### Ceramic Grill Holder in compact microwaves ovens Production after week 14/2008

EMWK 1050.0 - EMWG 1050.0 - MWGC 610.1

New ceramic holder just before being inserted in a special shaped hole.

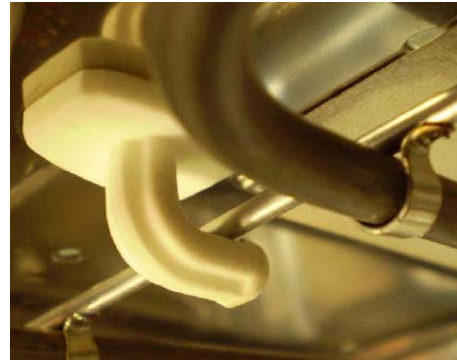
held in place by its own configuratoin after insertion on a special shaped hole and a 90° rotation.

New ceramic holder after insertion in the special shaped hole and 90° rotation.

The new ceramic holder isn't interchangeable on microwave ovens on the market, produced before week 15/2008.
